NC ACCESSIBILITY CODE

2012 NC Bldg Code Ch. 11
2009 ICC/ANSI A117.1

ANSI 603.2.2 Door Swing Limitations

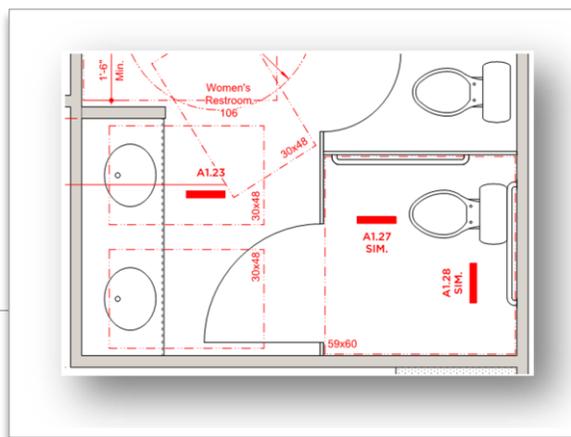
Q: In this project, only one of the two lavatories shown are required to be accessible. May the designer designate the first lavatory as the accessible lavatory, while leaving the corner lavatory as is, in front of the handicapped stall? If that is acceptable, won't the use of the non-accessible lavatory render the handicapped stall unavailable? Have I missed something that addresses this?

A: **ANSI 603.2.2** prohibits any door, even a toilet compartment door, from swinging into the clear floor area at any fixture. The area between the lavatories and the handicapped stall should be widened. The widening will remove the handicapped stall's door swing from the clear floor area at the lavatory. The additional space will also allow a 36" wide accessible route into the restroom and to the stalls, as required by **ANSI 403.5**.
